PZ&B Staff Combination Memorandum: Architectural Commission and Town Council Review

SUBJECT: ZON-24-0076 (ARC-24-0134) 369 S LAKE DR PH-A (COMBO)

MEETING: JANUARY 29, 2025 ARCOM

FEBRUARY 12, 2025 TC

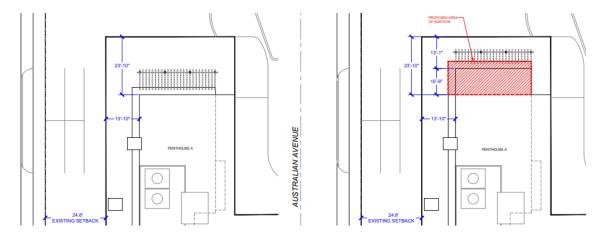
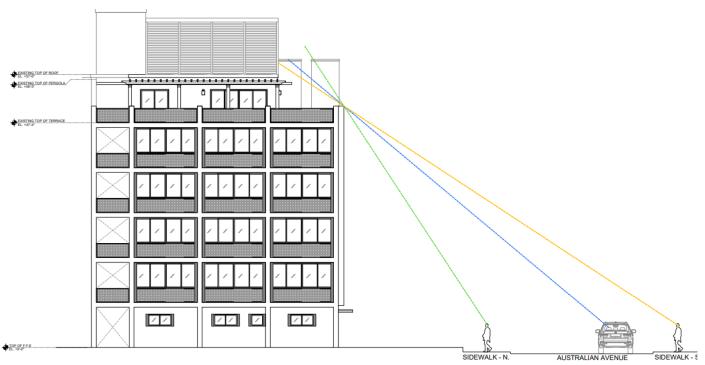
The existing trellis and pergola were approved via the granting of a variance (Variance #31-95) on September 10, 1996 for pergolas and trellises on penthouse A with associated height variances.

The proposed addition will occupy the a private outdoor space that has already been granted for height variances. There is no other adjoining penthouse unit that will be negatively impacted by the addition, as this penthouse unit is the end unit of the rooftop penthouses.

Further as evidenced in the line-of-site diagram, the proposed addition will not visually overwhelm the adjacent right-of-way as the actual existing building is already nonconforming in the stories and height and setbacks.
